## Underhill Farms Application

# REVIEW OF UNDERHILL FARMS TRAFFIC/TRANSPORTATION ANALYSES

Prepared for:  
Town of Yorktown

March 2023

Figure 2: Site Plan with selected locations highlighted (source: Submission by applicant dated 12/20/22)

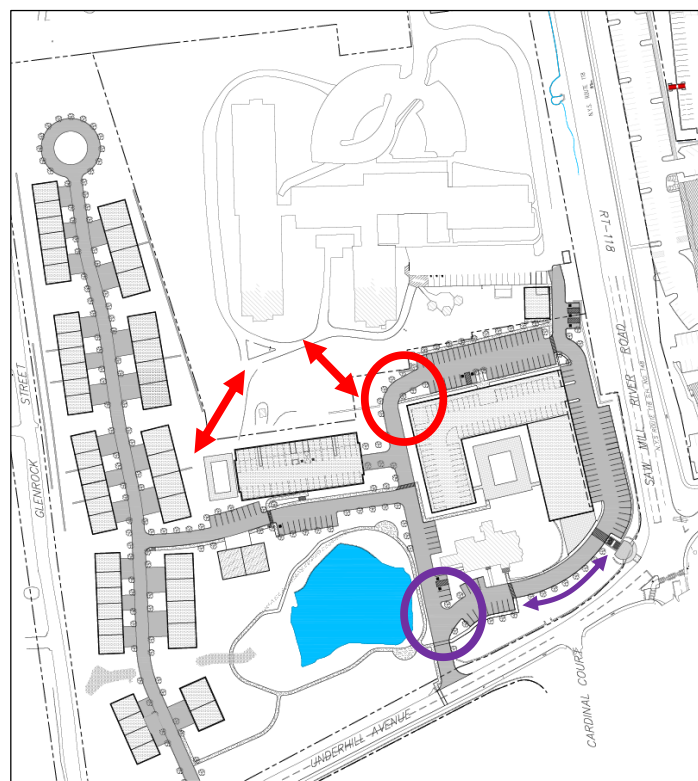
- 1) **Consideration be given to including a sidewalk connection along the southern curblin of the internal roadway to the south of the main mixed use building (highlighted by purple arrow in Figure 2.) This would allow pedestrians walking along this segment to avoid two crossings of this southern internal roadway.**
- 2) **The sidewalk network appears to be proposed to be located on private property at distance from the public right-of-way. It should be confirmed that the sidewalks between Glenrock and Beaver Ridge/Allan will be made accessible to the public at all times (or any restrictions clarified).**

The red circle drawn in Figure 2 highlights the northwest corner of the main proposed building, where the main loop access roadway is near to this corner of the building. **We recommend that the applicant confirm that the line of sight for drivers using this roadway is adequate to safely avoid colliding with a person walking on the loop roadway, taking into account the obstruction to view from the building corner.** It appears that one speed table is proposed in this area along the north-south roadway segment at the end of this curve; it may be desirable to include another on the east-west segment at the beginning of this curve.

It appears that sidewalks are not proposed along the red-circled section of the loop roadway. **We recommend that they be considered at this portion of the site** -- this would for instance enhance pedestrian connectivity between the senior center and the proposed recreation area around the lake.

Figure 2 above also shows two red arrows which depict possible locations for pedestrian/trailway access to Beaver Ridge. The western of these arrows is at the location of an existing disturbance dating to at

**We recommend that the Town discuss with the applicant whether cross-access concepts such as those indicated in Figure 2 are practical.**

The site plan shows a proposed internal street intersection in close proximity to the intersection of the main site access with Underhill Avenue (highlighted in the purple circle in Figure 2).

**We recommend consideration of aligning this intersection to be approximately a 90-degree intersection.**
